EXHIBIT A

STAFF REPORT

Final plat consisting of 42 buildable lots and 12 common lots on 4.97 acres of land in the R-15 zoning district.

Staff has reviewed the proposed final plat for substantial compliance with the approved preliminary plat (H-2020-0039) in accord with the requirements listed in UDC 11-6B-3C.2.

B. Final Plat (dated: 12/12/20)

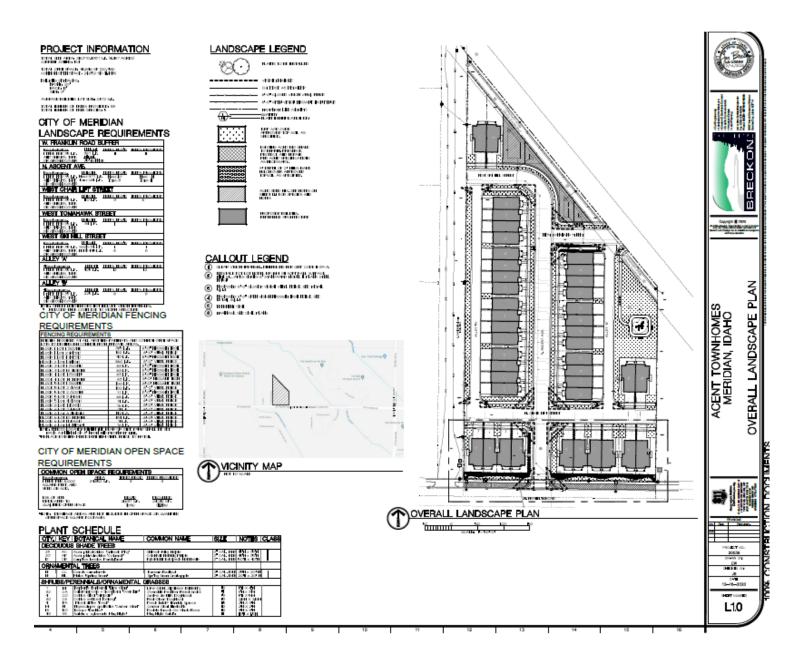
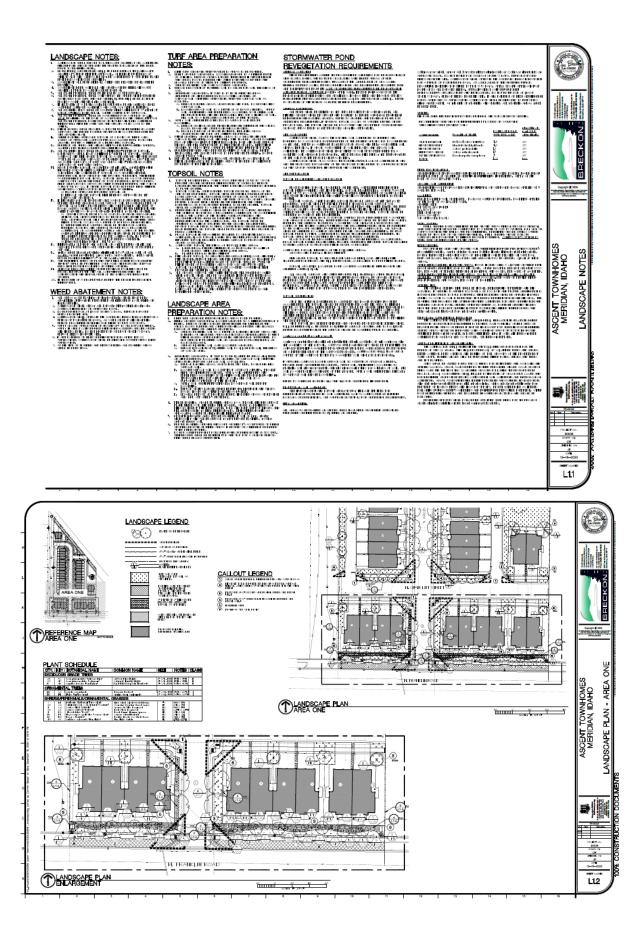
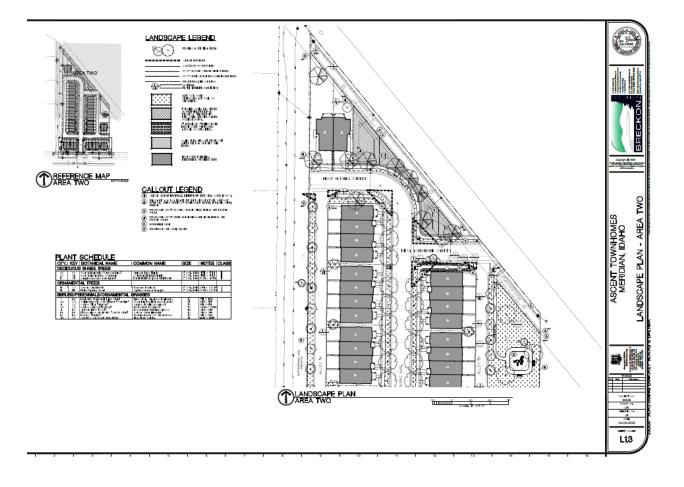
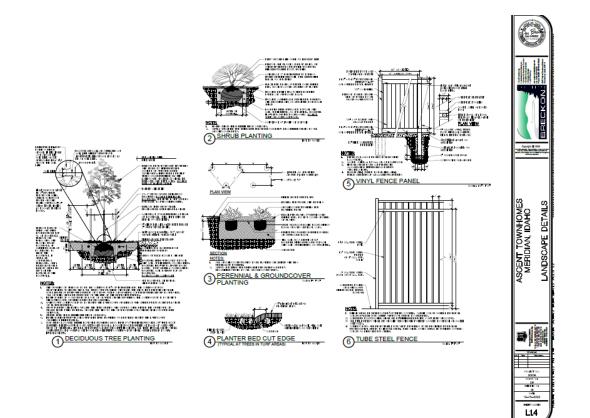
- 3. Prior to submittal for the City Engineer's signature, have the Certificate of Owners and the accompanying acknowledgement signed and notarized.
- 4. The final plat prepared by Idaho Survey Group, LLC stamped by Gregory G. Carter, dated: 12/12/2020, included in Section V.B shall be revised as follows:

- a. Graphically depict/call-out a temporary right-of-way easement via W. Franklin Rd. over the common lot (Lot 6, Block 1) instead of a "private" street. Include a note stating this easement shall be released when a local street connection is constructed to this site from a neighboring development; at such time, access will be restricted to emergency and pedestrian access only.

- b. Include a note stating the front yard of each individual lot shall be landscaped with a combination of lawn, groundcover, shrubs and trees as set forth in the TMISAP (see pg. 3-37); the Homeowner's Association shall be responsible for the maintenance of all landscaping on individual homeowner lots as set forth in the Development Agreement (Inst. #2020-110269).

- c. Depict zero lot lines on shared lot lines where structures are proposed to span across lot lines.
 - d. Include a note that prohibits direct lot access via W. Franklin Rd., other than emergency access, once local street access is available from an adjacent property.

- e. Revise plat note #2 to read Nampa & Meridian Irrigation District instead of the City of Meridian.
 - f. Add a note stating "The bottom of structural footing shall be set a minimum of 12-inches above the highest established normal ground water elevation."

- g. Add a note stating "Maintenance of any irrigation and/or drainage pipes or ditches crossing a lot is the responsibility of the lot owner unless such responsibility is assumed by an irrigation/drainage entity or lot owner's association."

C. Landscape Plan (dated: 12/15/2020) & Amenity Detail

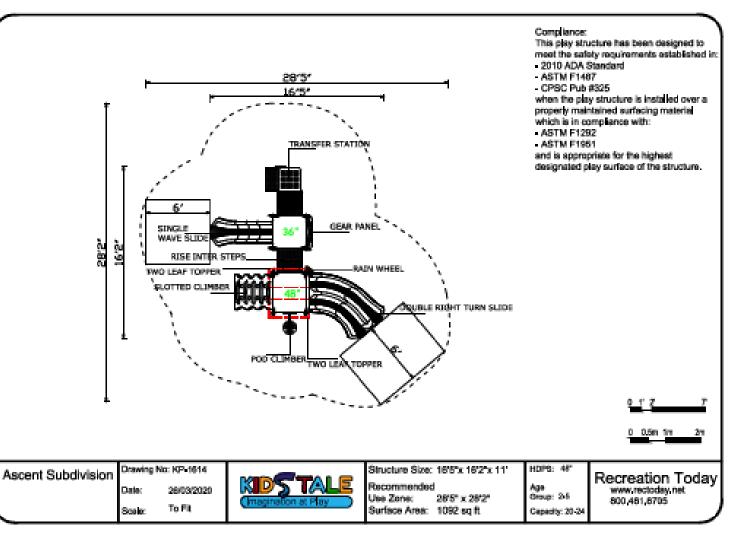
- 5. The landscape plan prepared by Breckon Land Design, dated 12/15/2020, included in Section V.C, shall be revised as follows:
 - a. Depict landscaping within the full width of the 25-foot wide street buffer along W. Franklin Rd. consistent with the standards listed in UDC 11-3B-7C.3. If ACHD doesn't allow such landscaping in the bio swale, an additional landscaped area outside of that area shall be provided totaling 25-feet.
 - b. Include a calculations table per the final plat application checklist that demonstrates compliance with the standards listed in UDC 11-3G-3E and 11-3B-7C.

D: Public Art

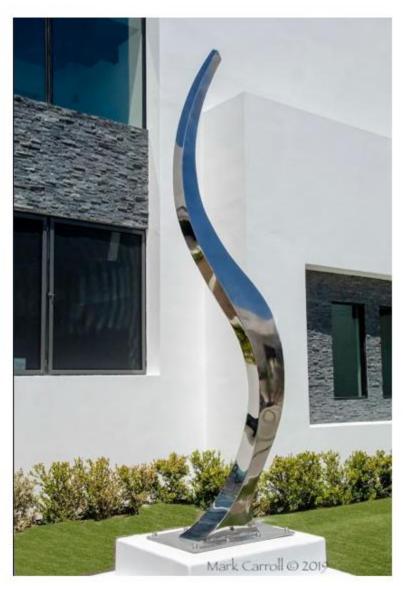
- 11. Public art with a high quality of design as shown in Section V.D shall be incorporated into the design of the streetscape along W. Franklin Rd. as set forth in the TMISAP (see 3-47) per the Development Agreement (Inst. #2020-110269).
